Transmission Services

Long-Term Firm Queue: Evaluation of Requests and Offer of Service, Version 9

Response to Customer Comments

Posted: 10/27/2014

Figure A: Initial Redirect TSR Y of Confirmed Parent reservation X

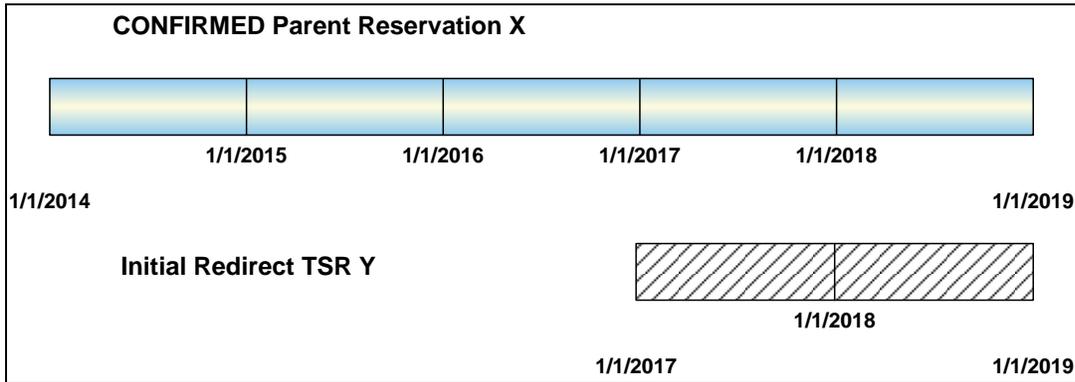
While it seems that Redirect TSRs are eligible to be issued Follow-on TSRs, the terms and requirements are unclear. If the Follow-on is issued, does the Transmission Customer have to take that capacity from the same Parent Reservation from which the Redirect has been made? Because the service type must match, is the Follow-on TSR a redirect from the same Parent as the Redirect currently in queue?

If the Initial Redirect TSR qualifies for Reservation Priority consistent with the terms of the Redirects Business Practice (i.e., the Redirect request terminates on the same Stop Date and Time of the Parent reservation), the customer would need to submit a renewal of the Parent reservation in order to submit a Follow-on Redirect TSR. The Follow-on Redirect TSR would be a Redirect request of the renewed Parent reservation. The Figures below provide an example. Assume a Transmission Customer has Parent Reservation X, with an Initial Redirect TSR Y off of and through the end of the term of Parent Reservation X (Figure A). Assume the Initial Redirect TSR Y is awaiting the completion of transmission upgrades and has not been awarded transmission service. If the Customer submitted a renewal of Parent Reservation X (Renewed Parent Reservation X1), then the Follow-on concept would permit the Customer to submit a Follow-on TSR for Initial Redirect TSR Y and continue awaiting transmission service under the Follow-on Redirect TSR (Y1) (Figure B). Follow-on Redirect TSR Y1 would be a Redirect of Renewed Parent Reservation X1 and, if granted, would take capacity from Renewed Reservation Parent X1. As reminder, the service duration of a Follow-on Redirect TSR must match that of the Renewed Parent reservation.

Figure B: Follow-on Redirect TSR Y₁ of Renewed Parent reservation X₁

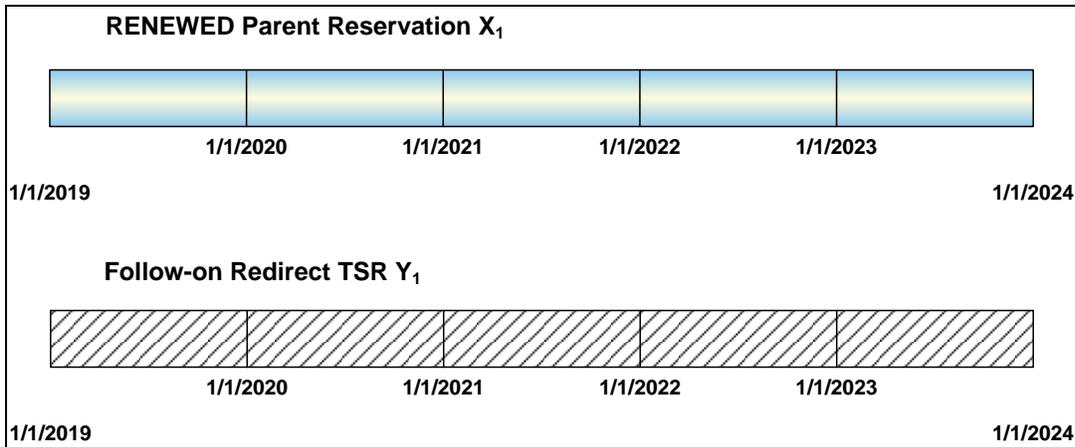
Section C.4(e)ii indicates that the Service Duration of the Follow-on TSR of type REDIRECT must match that of the RENEWAL Parent reservation. This language also seems ambiguous; does the RENEWAL Parent refer to the Parent from which the in-queue TSR was redirected from? Or is the Redirect required to submit a Renewal request, the result being the "RENEWAL Parent" referenced in the Business Practice?

The renewal Parent Reservation refers to the renewed Parent reservation from which the in-queue TSR was redirected (See Figure B above). In order for a Follow-on Redirect TSR to be submitted, the Parent Reservation must first be renewed. If the Parent Reservation has not yet been renewed, there exists no confirmed reservation from which the Customer can submit a Follow-on Redirect TSR. See above Figures for additional clarification to the Follow-on Redirect TSR concept.
